# Comments on GRETA-aux. detector trigger issues

Fig. 14. data acquisition system. The thick and thin lines represent multi-wire (ribbon) and individual cables (Lemo), GRETA WS 11/30/17 (WR)

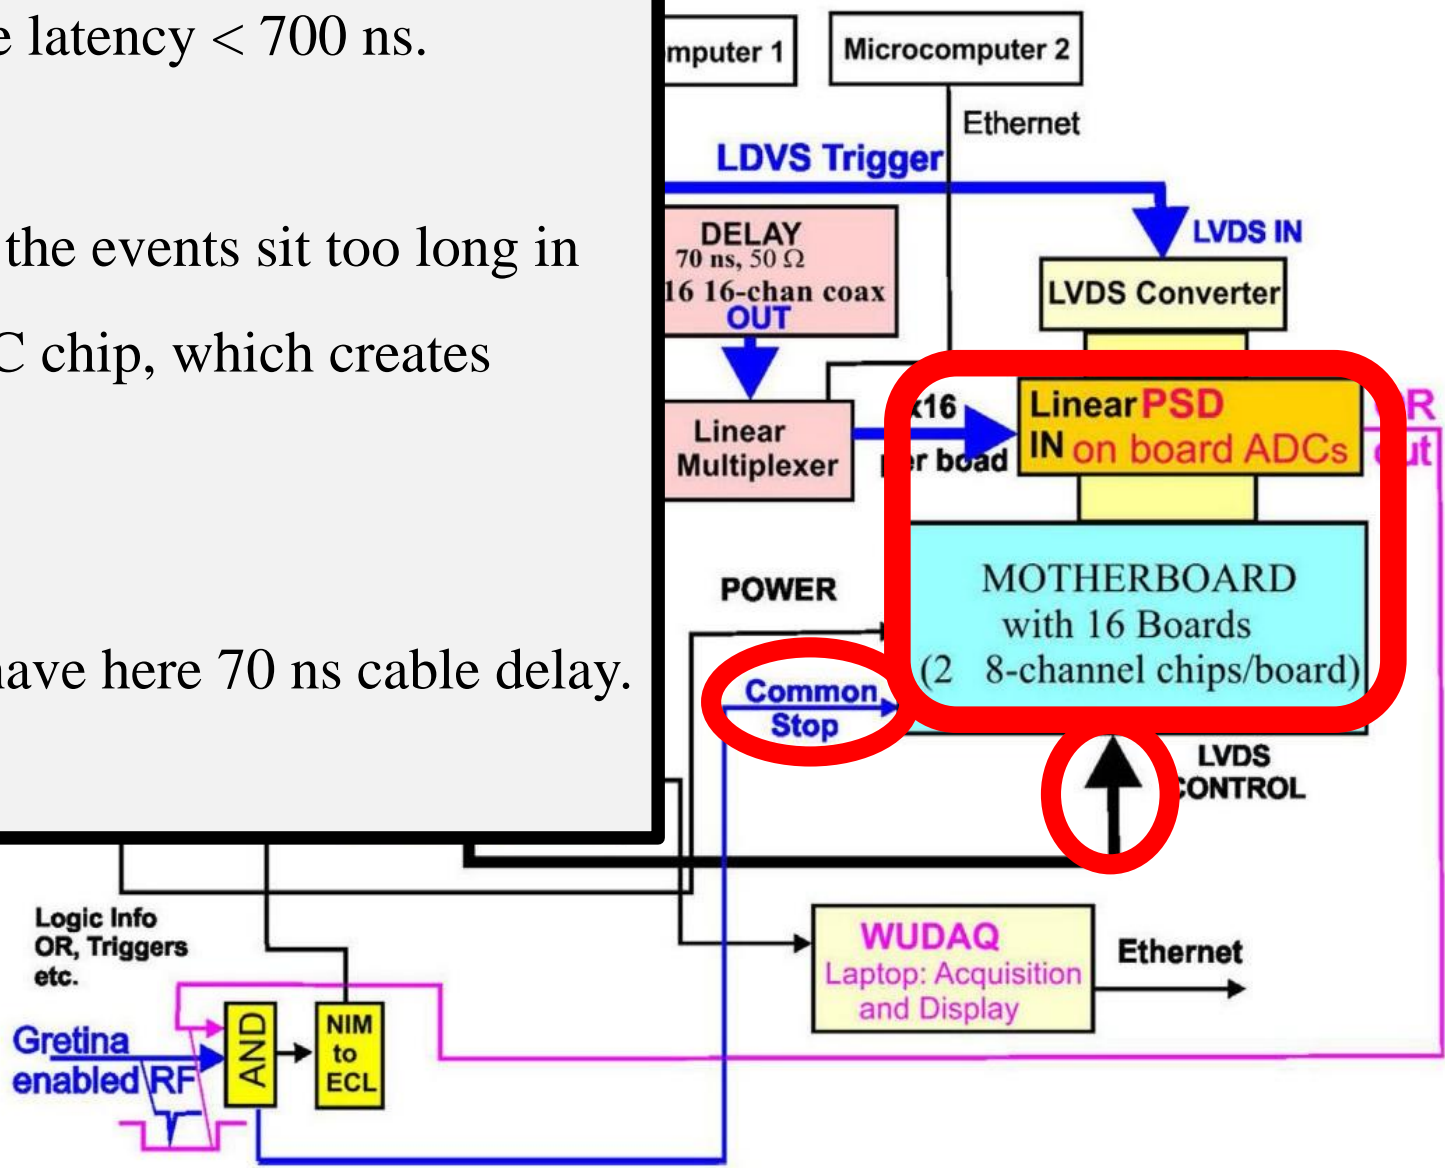
Acceptable latency < 700 ns.

Otherwise the events sit too long in the ASIC chip, which creates pileup.

BTW we have here 70 ns cable delay.
